construction bid document addendum 01

project: Southern Maine Community College - Horticulture Greenhouse
Midcoast Campus, Brunswick, Maine BGS # 3674

date: 12 November 2024

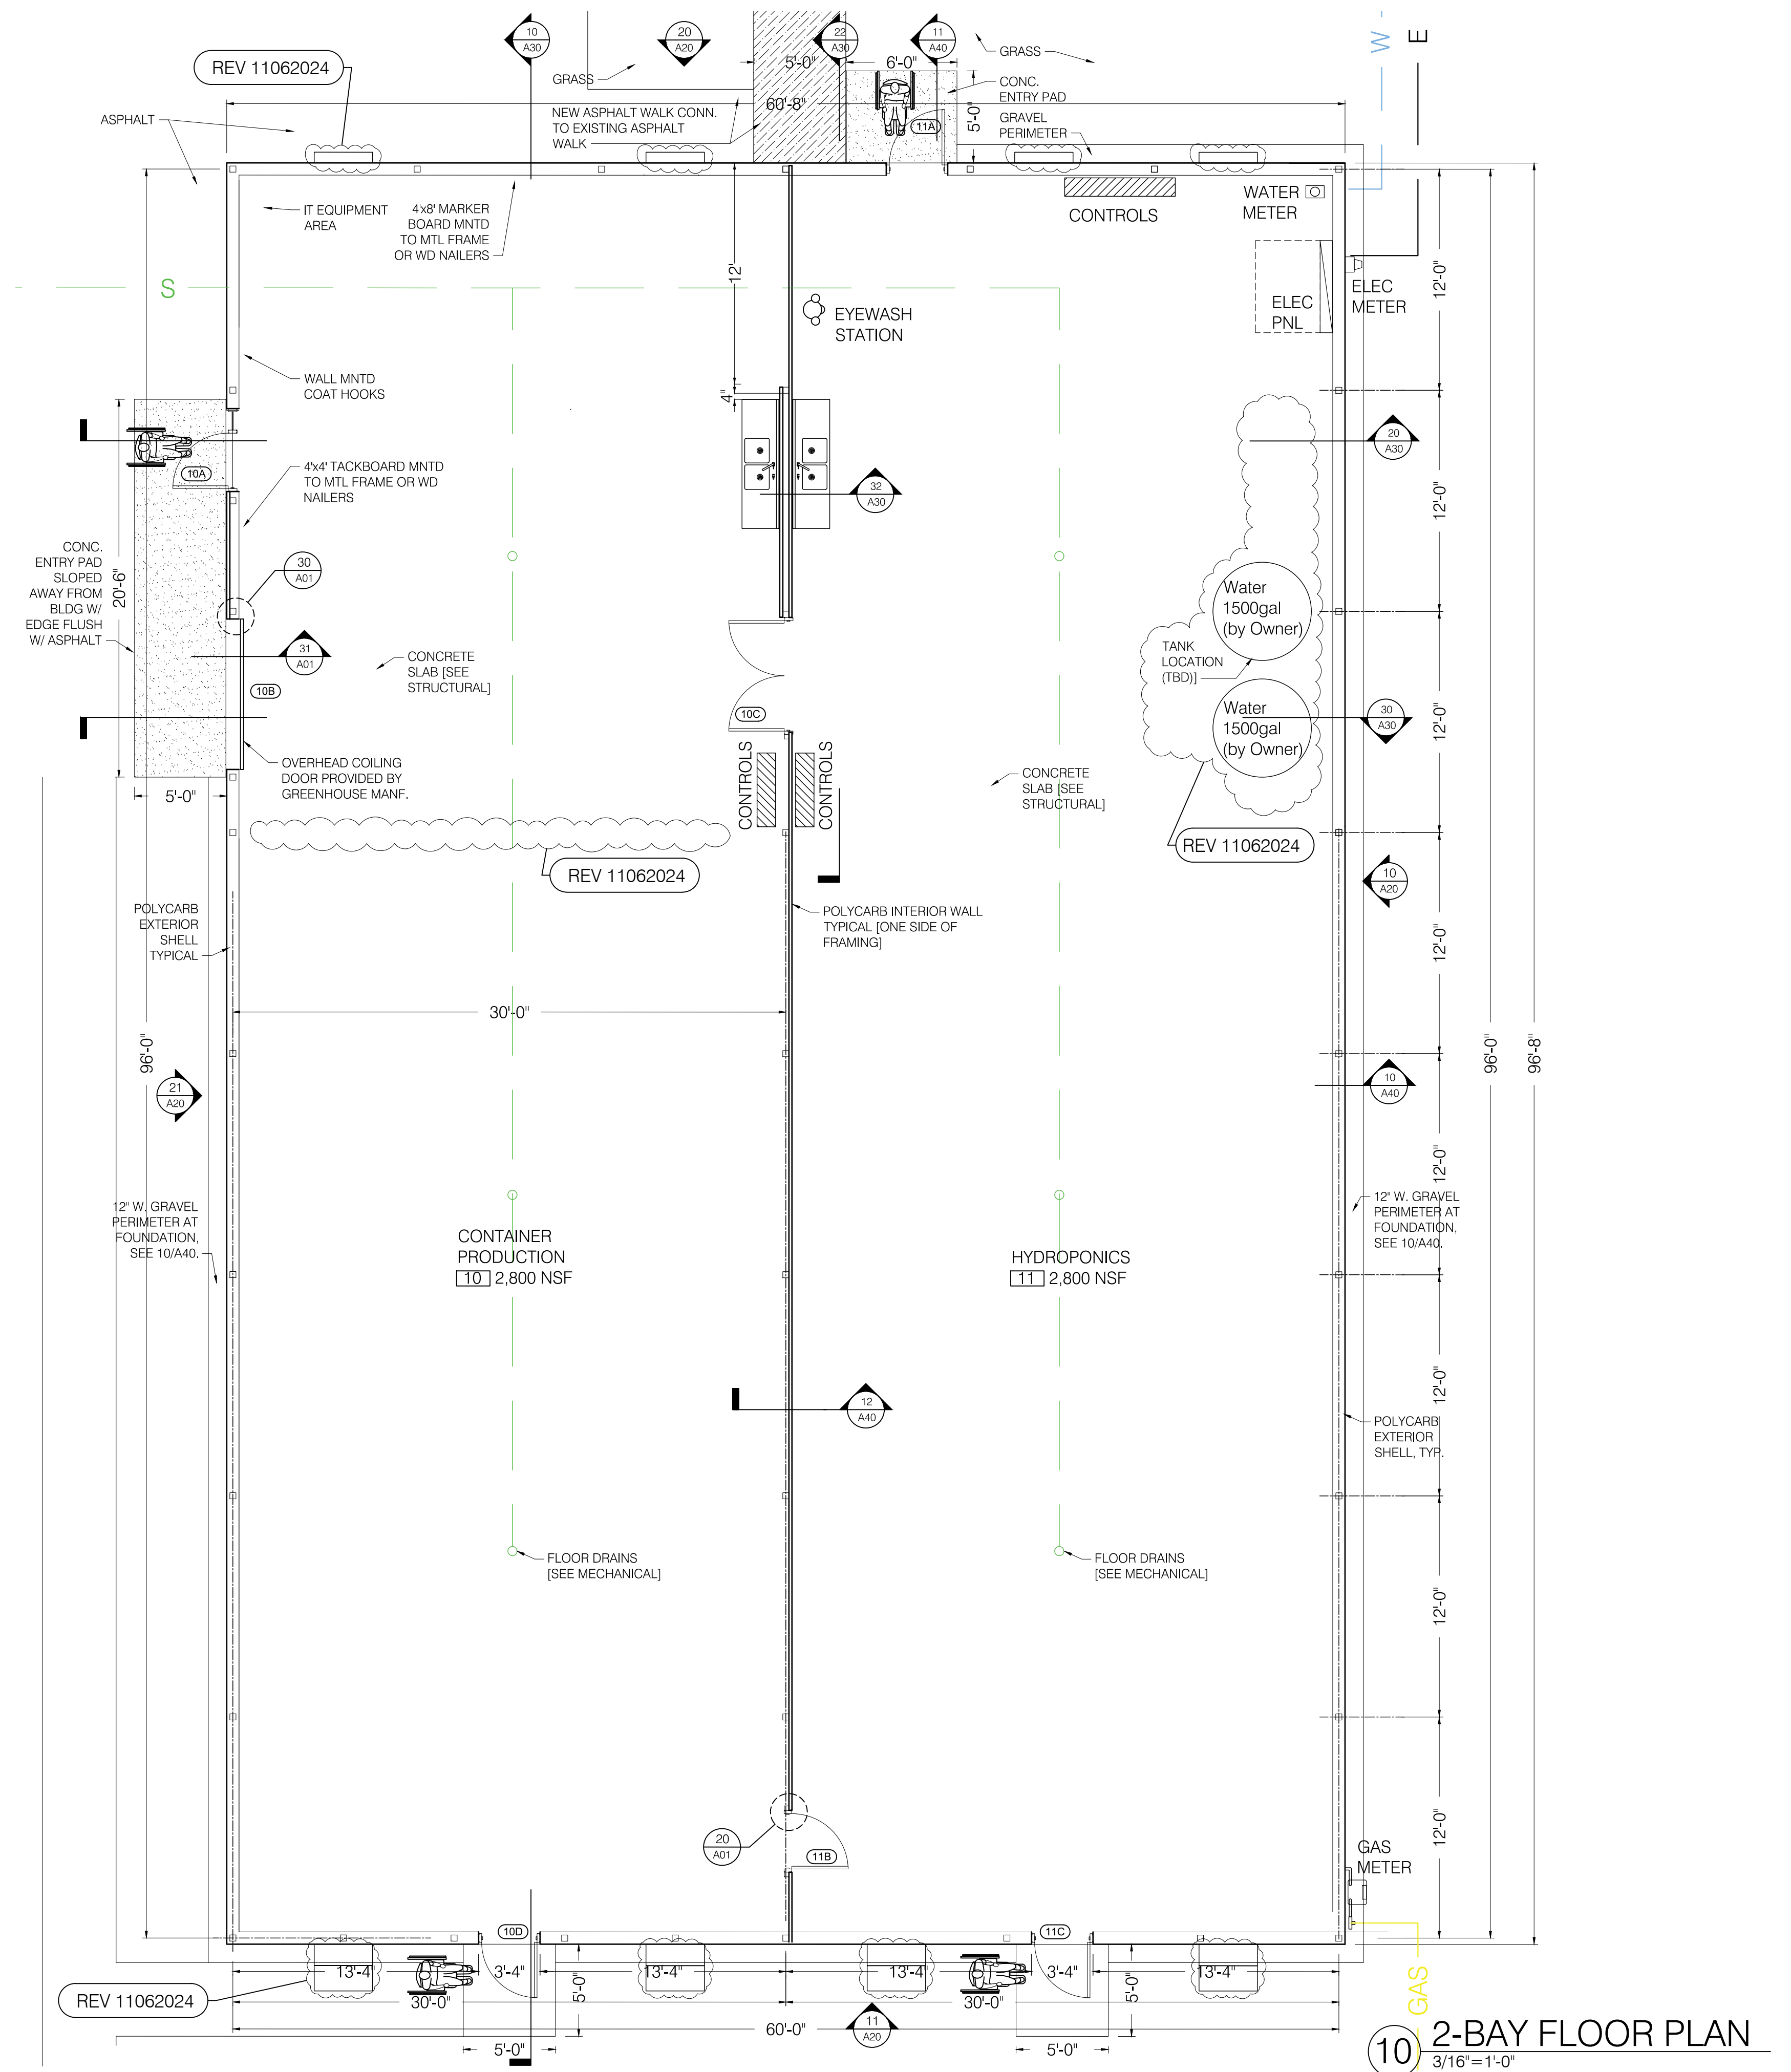
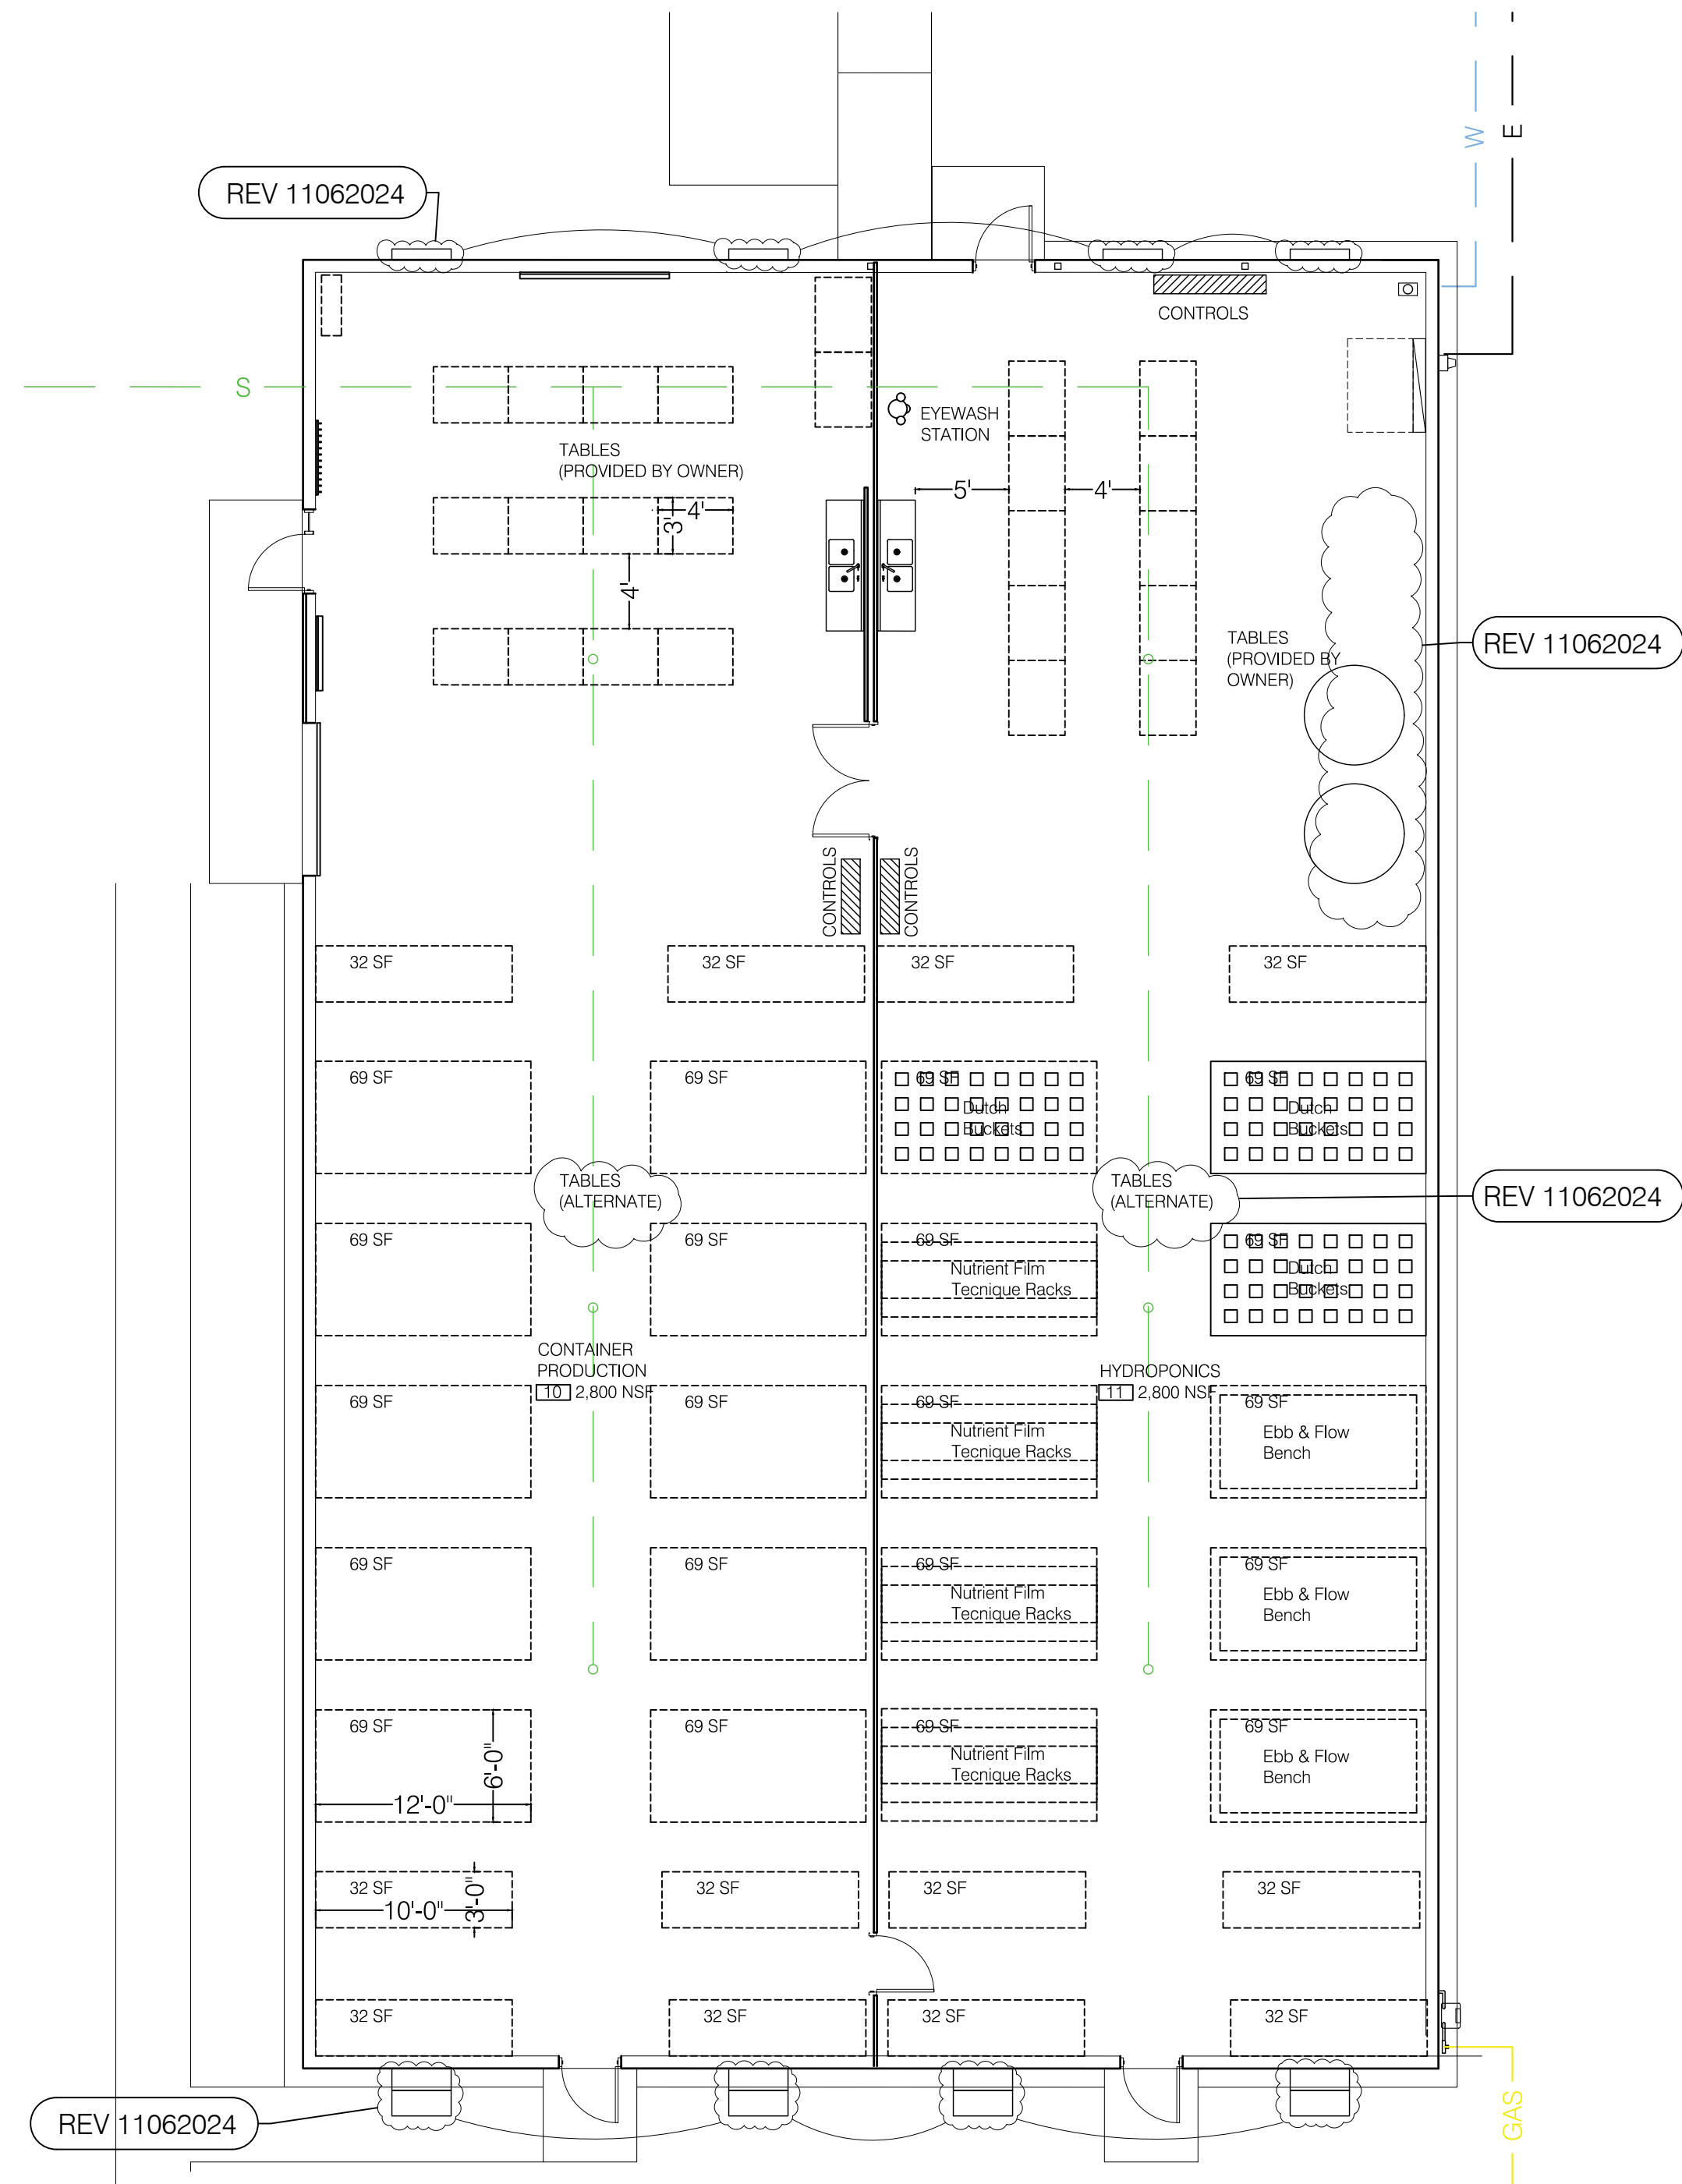
A10 GROUND LEVEL & FURNITURE PLANS: Column dimension string to match S1.1 with equal 12'-0" center lines. Tank storage omitted. Exhaust and dampers shown.

10 ROOF PLAN
3/16" = 1'-0"

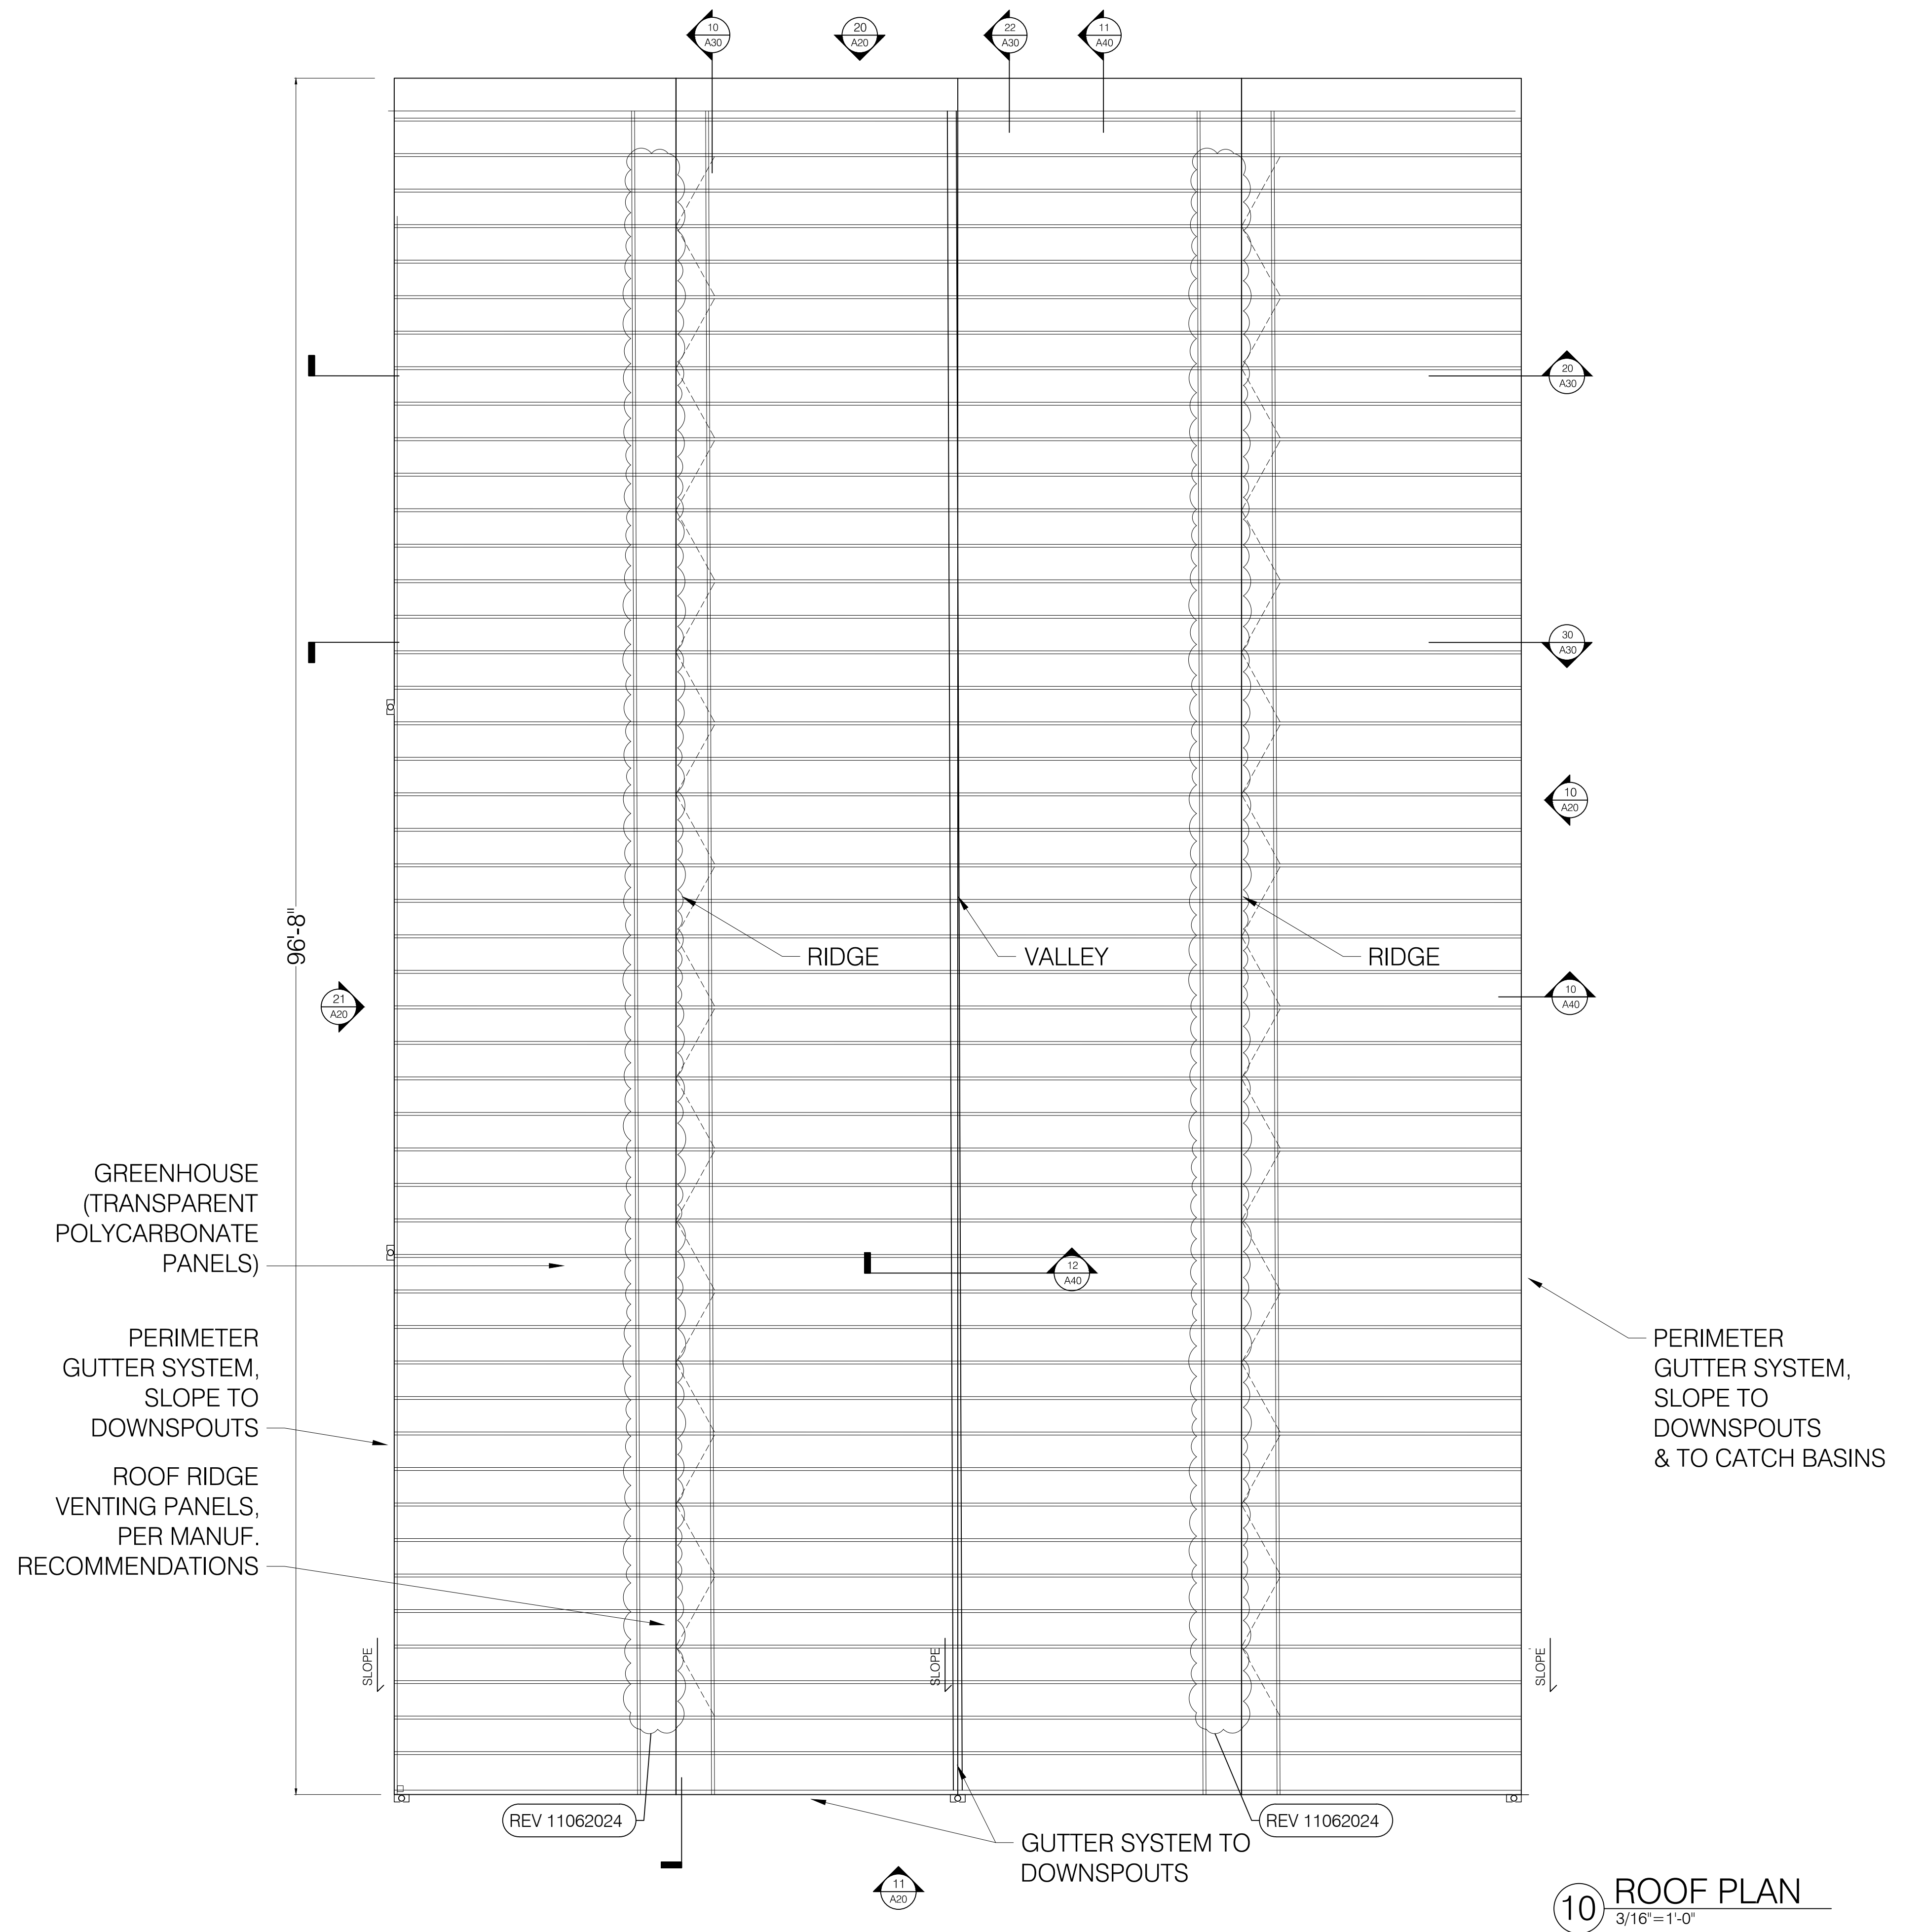
9. **Ventilation system.** Revisions as follows and as noted on attached drawings.
OMIT: West side of motorized gull-wing ridge vent. Maintain east side of motorized ridge vent on both bays.
OMIT: Manually operated wall ventilation.
OMIT: South elevation upper exhaust fans. Maintain (2) two lower exhaust fans on both bays per Greenhouse manufacturers sizing and specifications.
OMIT: North elevation upper intake dampers. Maintain (2) two lower intake dampers on both bays per Greenhouse manufacturers sizing and specifications.

A11 ROOF PLAN: Ridge ventilation revised.
